[Docket No. FAA-2017-0288; Product Identifier 2017-CE-007-AD; Amendment 39-19231; AD 2018-06-11]

Airworthiness Directives; Textron Aviation Inc. Airplanes

ACTION: Final rule.

SUMMARY: We are adopting a new airworthiness directive (AD) for certain Textron Aviation Inc. Models A36TC, B36TC, S35, V35, V35A, and V35B airplanes. This AD was prompted by a fatal accident where the exhaust tailpipe fell off during takeoff. This AD adds a life limit to the exhaust tailpipe v-band coupling (clamp) that attaches the exhaust tailpipe to the turbocharger and requires an annual visual inspection of the exhaust tailpipe v-band coupling (clamp). We are issuing this AD to address the unsafe condition on these products.

Figure 1 to paragraphs (k)(1)(iii) and (v) of this AD: Cross section of v-band coupling

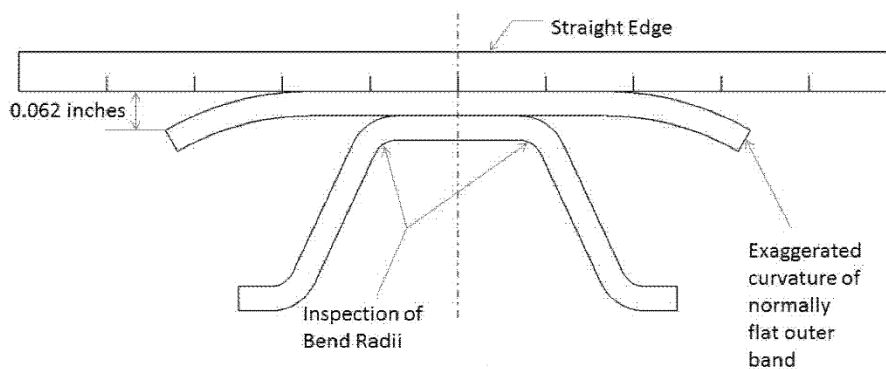
(iii) Visually inspect the flatness of the outer band using a straight edge. Lay the straight edge across the width of the outer band. The gap must be less than 0.062 inches. See figure 1 to paragraphs (k)(1)(iii) and (v) of this AD. If the gap exceeds 0.062 inches between the outer band and the straight edge, do not re-install the v-band coupling. Before further flight, you must install a new v-band coupling and restart the hours TIS for the repetitive replacement of the v-band coupling.

(v) Visually inspect the bend radii of the coupling v-retainer coupling segments for cracks. Inspect the radii throughout the length of the segment. See figure 1 to paragraphs (k)(1)(iii) and (v) of this AD. If any cracks are found, do not re-install the v-band coupling. Before further flight, you must install a new v-band coupling and restart the hours TIS for the repetitive replacement of the v-band coupling.
